Cadia Community Sustainability Network (CCSN) Comments/Objections To Newmont/Cadia Valley Operations (CVO) Modification 15 Tailings Storage Facility Embankment Buttressing

1 Embankment Buttressing

Newmont
CADIA
CADIA VALLEY OPERATIONS
Typical Cross Section through the
Northern Tailings Storage Facility
Main Embankment
Figure 2-1b

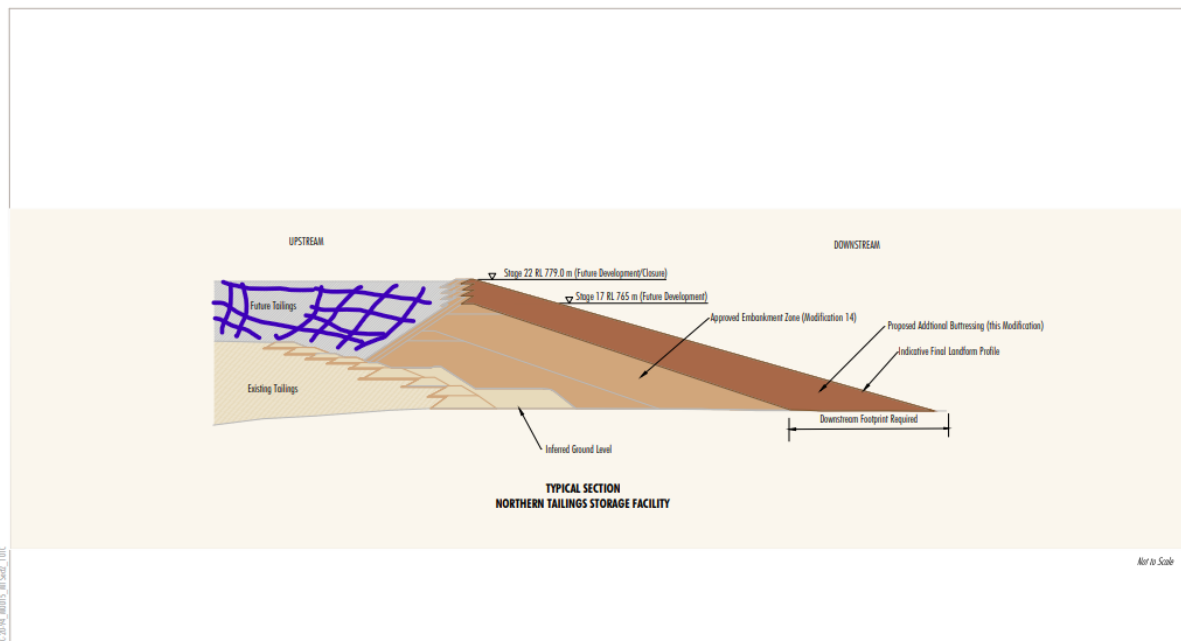
Changing the tailings dam construction from upstream to centreline or downstream will result in a significant increase in storage capacity (blue cross hatched area). The dam wall will effectively be built in a line upwards rather than building over the current tailings dam. The Advisian model (Appendix D – Groundwater Impact Assessment) for the NTSF and STSF revises the cell matrix used to model the tailings dam footprints and identifies an increase in the tailings dam footprint area by 200 modelled cells, approximately 20% (Figure 5-2).

Descriptions that buttressing the outer slopes of both the NTSF and STSF and moving to a centreline or downstream lift has no change in the volume of tailings material stored or the footprint of the stored tailings is false. The assertion that all tailings deposition would remain within existing Mine License (ML) is totally misleading. The notice of exhibition for the Mod is deliberately intended to mislead and downplay the significance of Mod 15.

Figure F-6: Sensitivity analysis showing predicted annual average PM_{10} concentrations due to emissions from the Modification and other sources ($\mu\text{g}/\text{m}^3$)

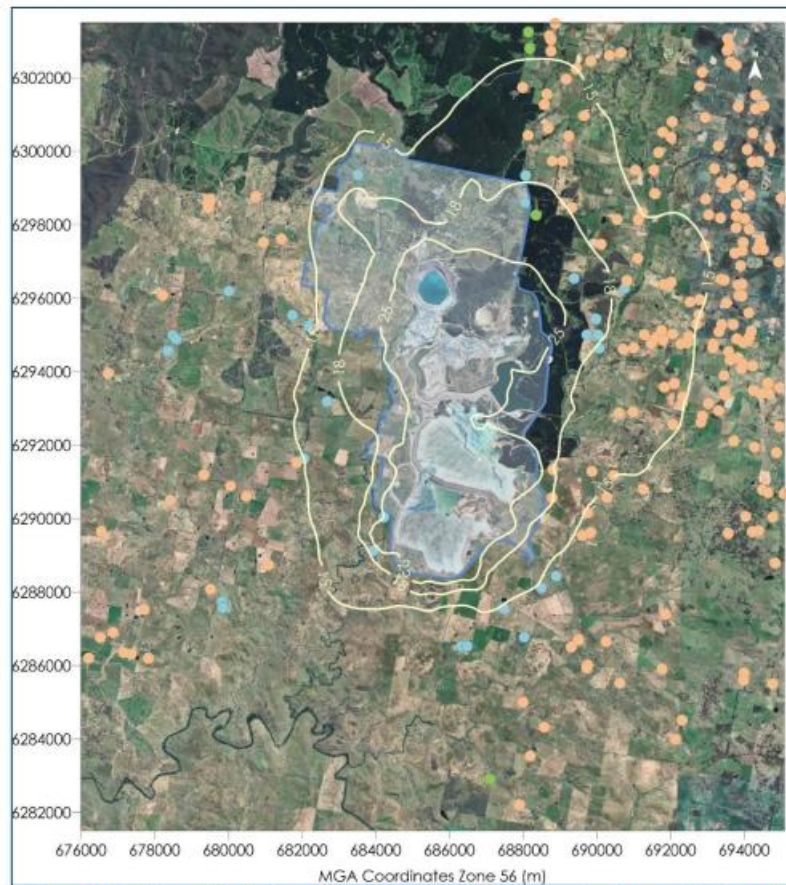
On the basis a precautionary approach is adopted, 10-20% of the PM₁₀ is RCS and there are real concerns in regard to life time exposure to RCS around the CVO mine, refer to Todoroski PM₁₀ isopleth below.

The Todoroski data (which we believe is significantly understated) identifies approximately 50 receptors adjacent or inside the PM_{10} $0.015\text{mg}/\text{m}^3$ isopleth. Based on an RCS fraction of 20% of PM_{10} , RCS would be at least the EPA interim criteria.

Contrary to Todoroski assertions, we cannot dismiss concerns that multiple residents are living with RCS levels close to or in excess of the EPA's interim criteria of $0.003\text{mg}/\text{m}^3$.

- **RCS should be modelled based upon PM₄**
- **CVO clean all water tanks in the district, and provide clean drinking water to all residents**
- **All dust exceedances be recorded by an independent authority. Self-reporting by CVO cannot be relied upon.**

L - Professor Brian Gulson Sludge Sample Map from "An Evaluation of Lead Isotopic and other Geochemical Information of Relevance to the Cadia Mine operations".

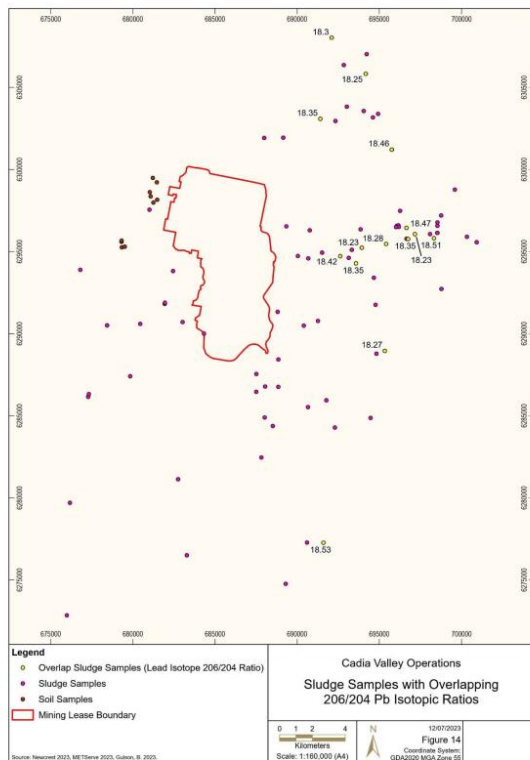
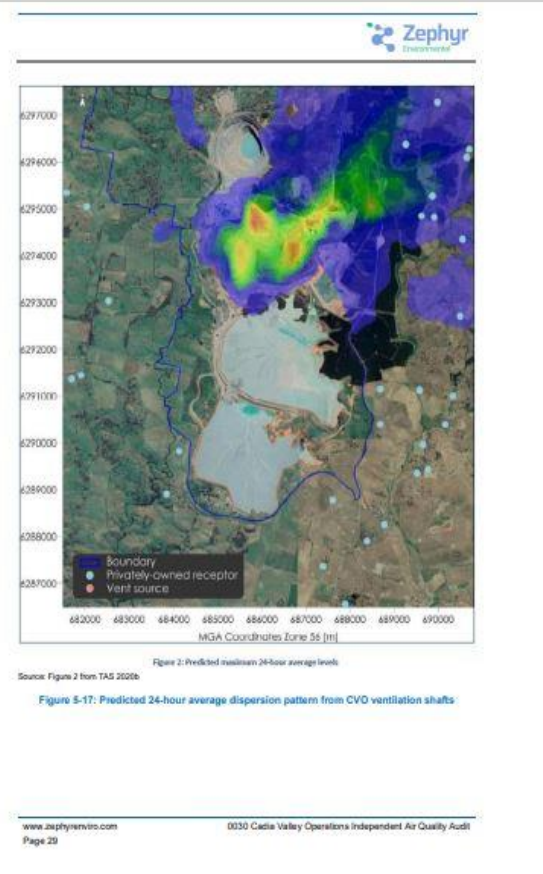
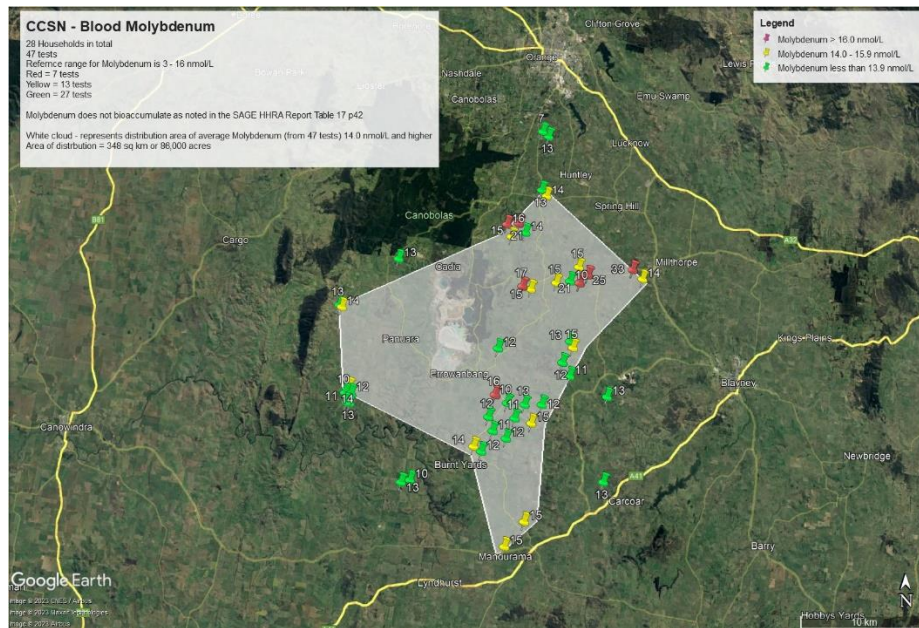
In addition, we believe we have identified what appears to be a pattern of distribution:

The red pin (33) to the east near Millthorpe is a 4-year-old child with a blood level of 33. CVO has a molybdenum plant.
